**ALTAMONT WATER TREATMENT PLANT
RESPONSE TO COMMENTS ON THE
DRAFT ENVIRONMENTAL IMPACT REPORT**

Zone 7 of Alameda County
Flood Control and
Water Conservation District

EIP Associates

May 4, 2001

FIGURE 2-2
POTENTIAL SITES FOR THE
ZONE 7 ALTAMONT WATER
TREATMENT PLANT
 Altamont WTP DEIR
 Livermore, CA

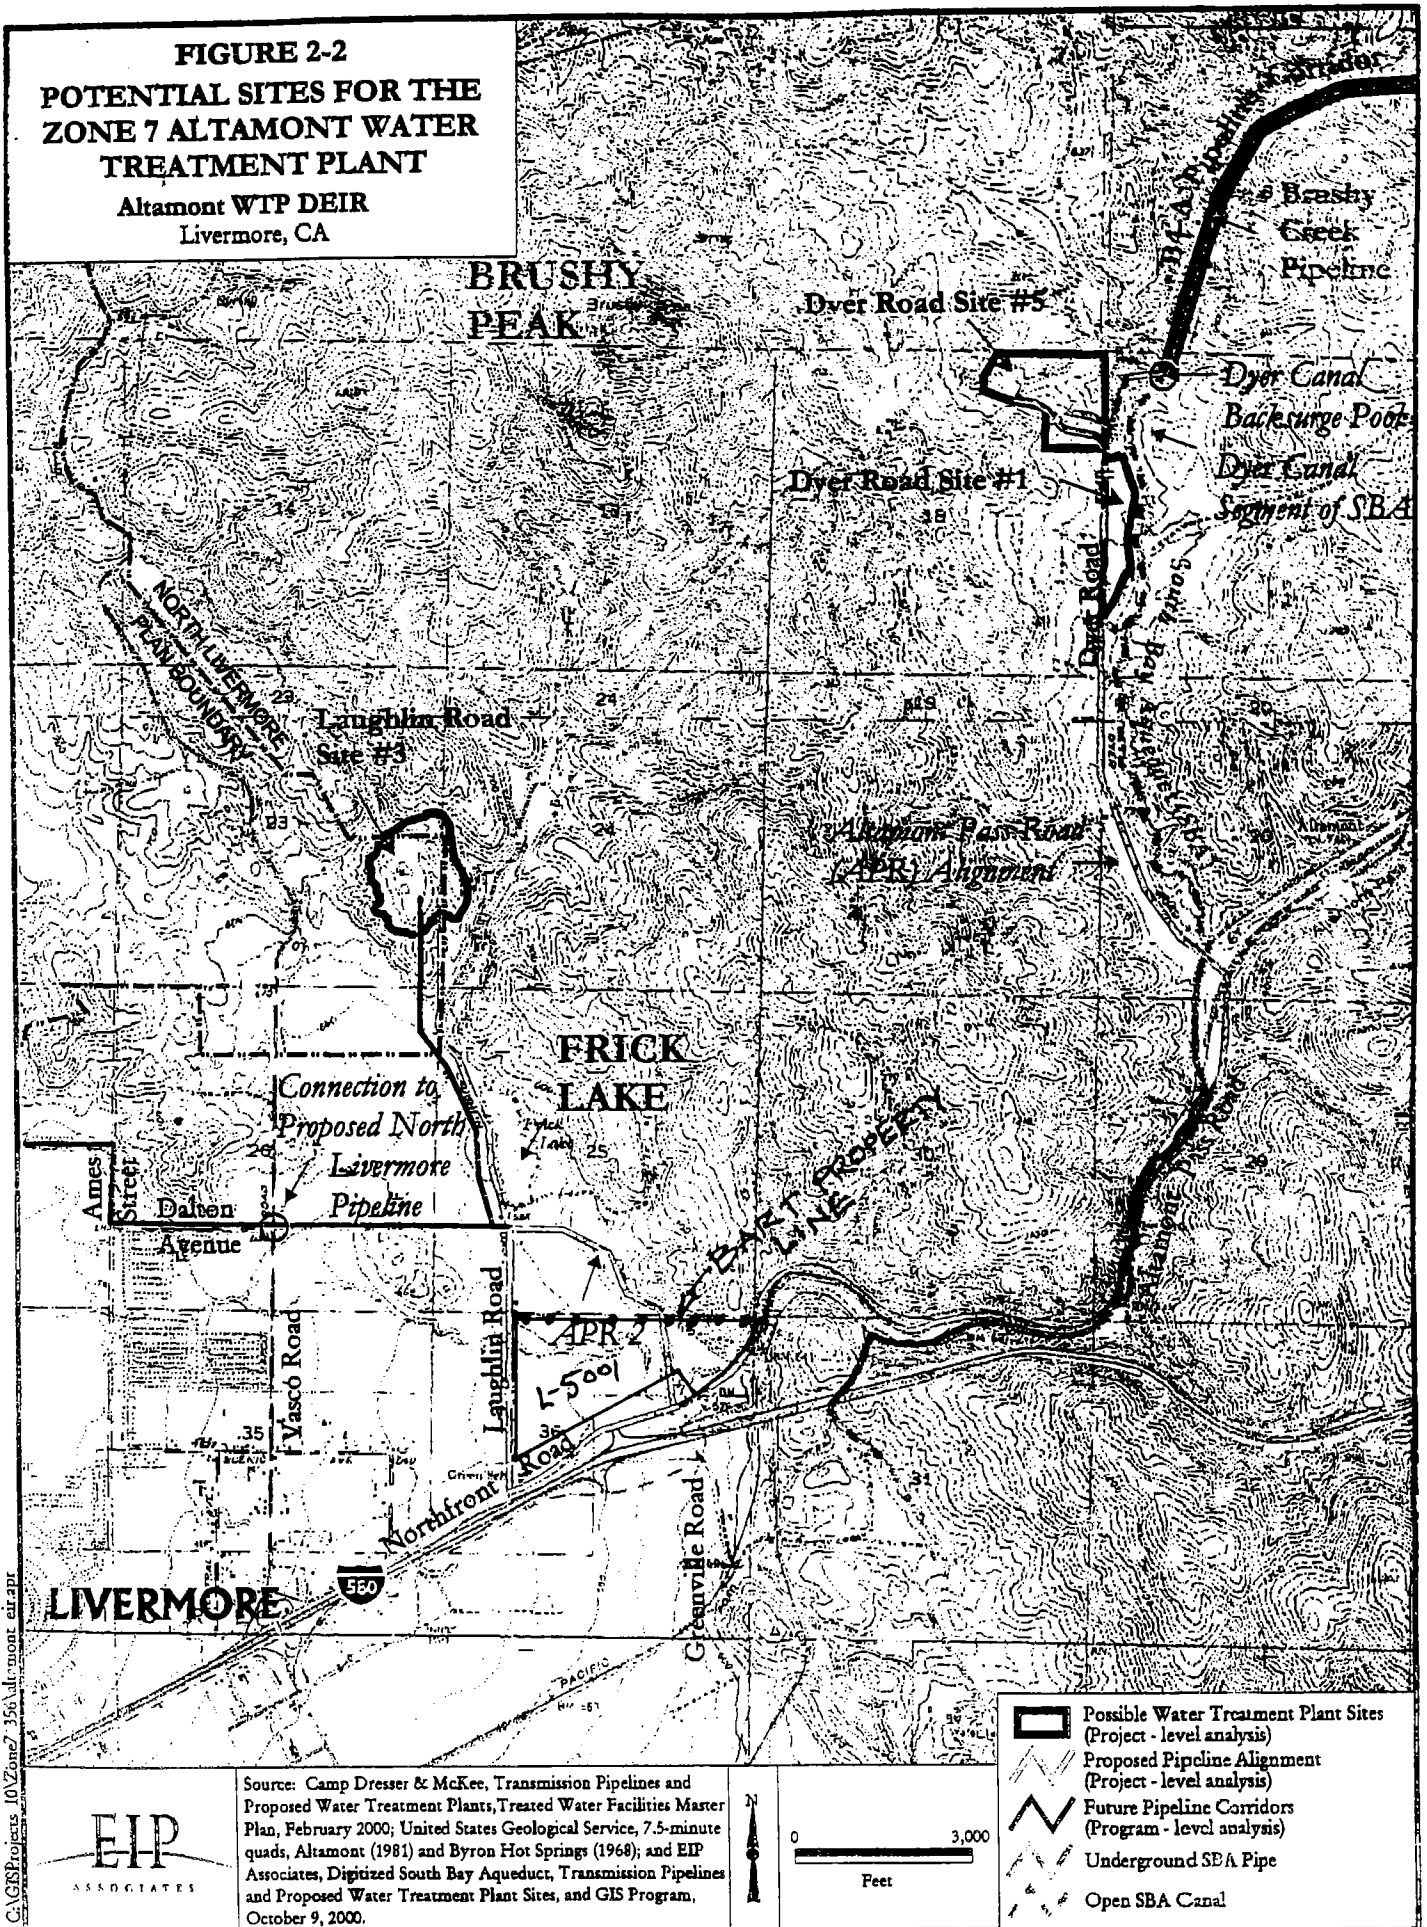
the required pipeline easement. Please see the attached markup of Figure 2-2 for the location of this recommend realignment. You may contact BART's District Surveyor, Mr. Les Frelich, at (510) 464-6161 if you have any questions regarding this suggested relocation.

--- BART SUGGESTED "APR 2"

Following BART's request for an alternative alignment which would not bifurcate the buildable area of their parcel (see Comment 4.2), bounded on the east, south, and west by Altamont Pass, Northfront, and Laughlin Roads, Altamont Pass Road Three (APR-3) was proposed (see revised Figures 1-1 and 2-2). Consideration was given initially to an alignment that would parallel the northern boundary of BART's parcel, coincident with the north section line of Section 36, Township 2 South, Range 2 East. Subsequent discussions with Mr. Les Freligh, BART's District Surveyor, confirmed that the ridge at the eastern end of that alignment is too steep to accommodate the needed construction equipment and maintenance road for the pipe. An alignment around the base of the ridge is considered a better approach, and would be acceptable to BART and to Zone 7. Consequently, APR-3 would follow the base of the ridge from Altamont Pass Road north to the Section 36 boundary and east to Laughlin Road about 2,300 feet south of Frick Lake. Approximately 5,400 feet of pipe could be saved by using this alignment.

FIGURE 2-2
POTENTIAL SITES FOR THE
ZONE 7 ALTAMONT WATER
TREATMENT PLANT

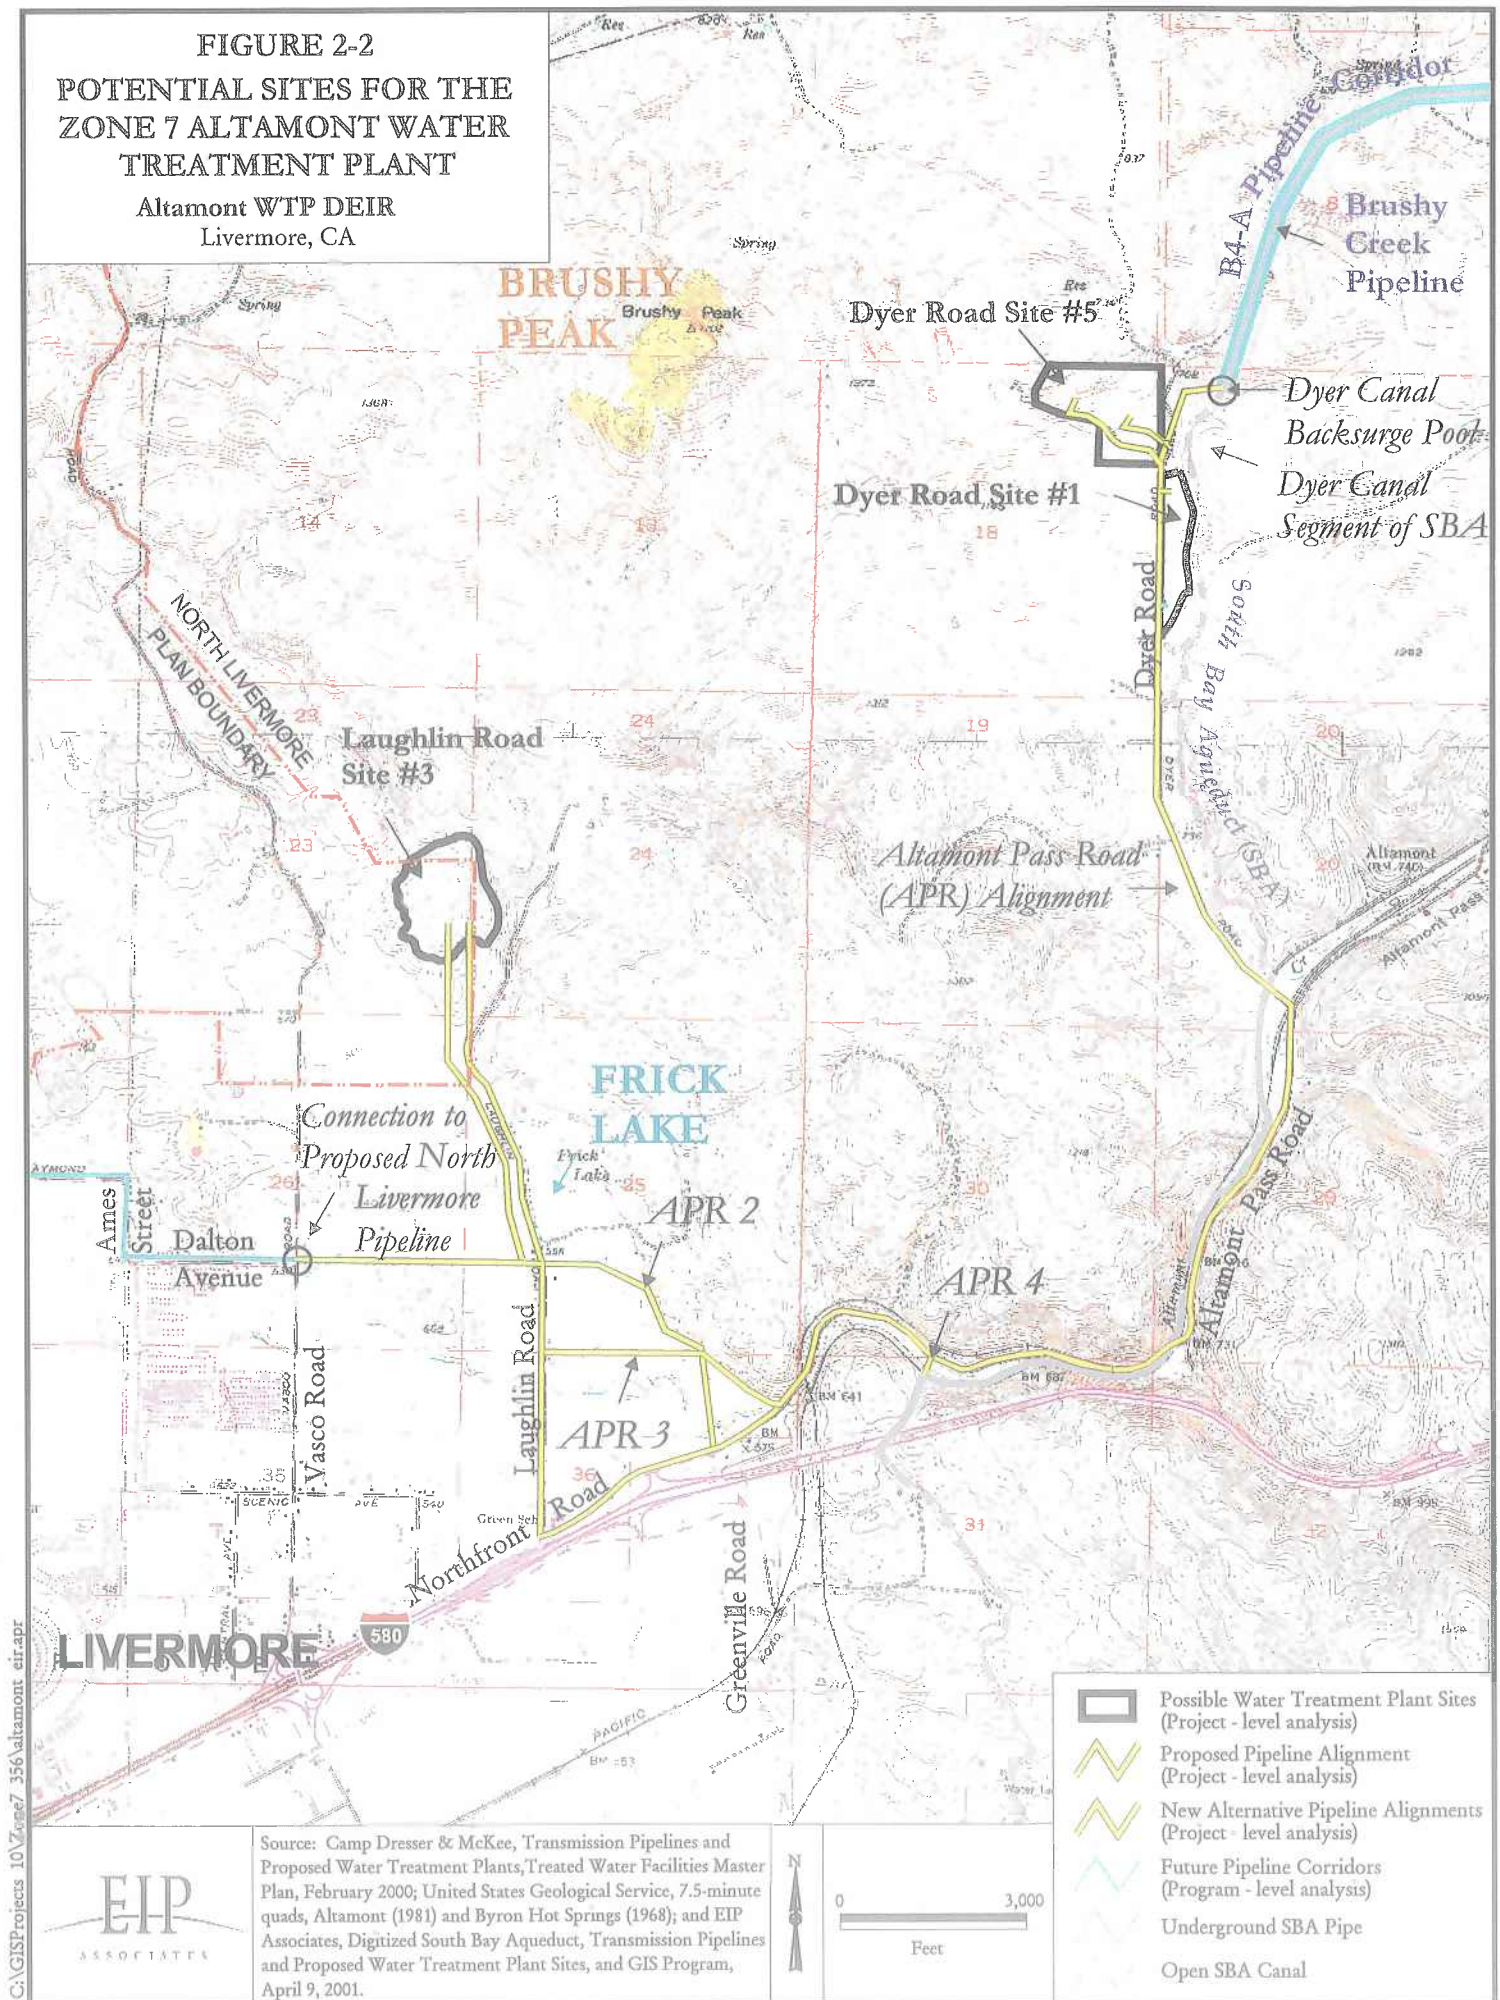
One optional alignment, identified in revised Figures 1-1 and 2-2 as Altamont Pass Road Two (APR-2), for the proposed raw water line to Laughlin Road Site #3, could decrease the total length of the pipeline between the Dyer Canal Backsurge Pool and Laughlin Road Site #3 by about twelve percent. Approximately 4,000 feet of pipe could be saved by angling north from Altamont Pass Road at the intersection of Greenville Road, and extending the alignment across the open undeveloped area to Laughlin Road. The alignment would cross Altamont Creek north of the intersection of Altamont Pass and Greenville Roads, traverse open grazing land, and enter Laughlin Road about 300 feet south of Frick Lake.

These alternative alignments are identified in revised Figures 1-1 and 2-2 as Altamont Pass Road Three (APR-3) and Altamont Pass Road Four (APR-4) and are described on page 4-2, Text Changes to the Draft EIR, of this Response to Comments document. Additional information appears in Responses 4.2 and 16.4. The potential impacts of these alignments are the same in type and severity as other off-road portions of the project, as described throughout the Draft EIR, and would be subject to the same mitigation measures.

The segment of the APR-4 alternative alignment which is different from the other three alternative alignments is designated on revised Figures 1-1 and 2-2 in Section 4, Text Changes to the Draft EIR, of this Response to Comments document. It would leave the existing SBA pipeline approximately at the point where the SBA turns southwest toward Highway 580, and extend under Altamont Creek to Altamont Pass Road. There it would turn west to follow the same route as the APR alternative (in existing roads) or as the APR-2 or APR-3 alternatives (partly overland and partly in existing roads) to Laughlin Road Site #3.

EXISTING VIEW

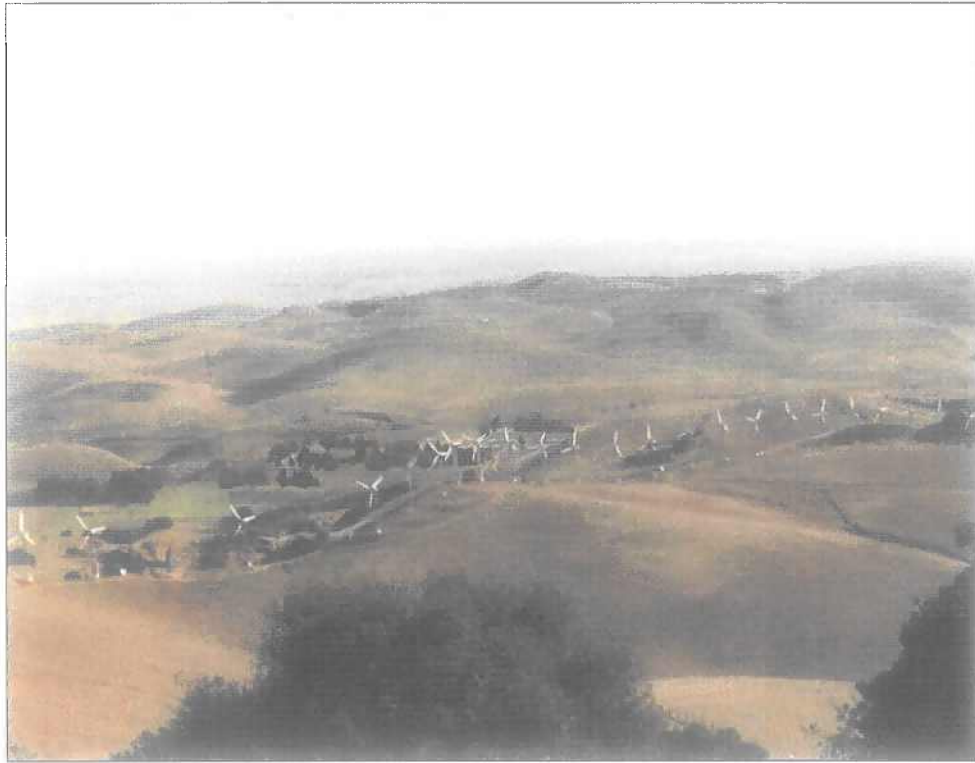
The visual analysis for the visual impacts from Brushy Peak of the Laughlin Road Site #3 rely upon a poorly reproduced 3" x 5" photograph on Figure 3.3.2-2B of the EIR. This photograph is very grainy and hazy, and is not suitable for the reader to make any kind assessment of the visual impacts. This District granted permission to Zone 7 so that such an analysis could be adequately performed. Unfortunately, this photograph is useless in

- 5.7 The comment notes the poor reproduction quality of Figure 3.3.2-2B in the Draft EIR. A better reproduction of the mitigated constructed view of Laughlin Road Site #3 from Brushy Peak is presented in Section 4, Text Changes to the Draft EIR, of this Response to Comments document. Additionally, photographs of the existing condition and constructed view of Laughlin Road Site #3 from Brushy Peak that were not presented in the Draft EIR, appear in Section 4 of this document for further explanation and

Figure 3.1.2-2C, Constructed View from Brushy Peak, shows a computer-generated image of one possible configuration of the Altamont WTP on Laughlin Road Site #3. The site is in the center of the photo. The facilities visible on the site include buildings to the right and lagoons to the left. In this view, the western edge of the site and less than 10 percent of the facilities on the north side of the site would be screened by an 800-foot-high ridge between the site and Brushy Peak. This relationship is shown in Figure 3.1.2-6, Laughlin Road Site #3 Profile, which illustrates the topography along the line-of-sight. The computer-generated image is scaled to fit the view as it would be seen with the unaided human eye. Thus the tallest building (about 22 feet at the peak of the roof) is visible against the ridge top, the grazing land to the south, and the subdivisions north of I-580. The berm of the landfill cell to the right of the BFI staging area is higher than the water treatment plant building.

Figure 3.1.2-2D, Mitigated Constructed View from Brushy Peak, shows the computer-generated image of the Altamont WTP on Laughlin Road Site #3 surrounded by clusters of evergreen and oak trees, the same age as those in Figure 3.1.2-2B, Mitigated Constructed View. About 50 percent of the facilities are visible through the tree screen on the north and west sides of the site. Here again, deep green tones for the structures would be less visible at this stage of vegetation growth. Because other large clusters of trees appear in the background, the clusters around the water treatment plant tend to blend with their surroundings. Under these conditions, the Altamont WTP itself would be less visible than the staging area for the BFI landfill (to the right of center of this photo) or the rows of residential and commercial structures in the background.
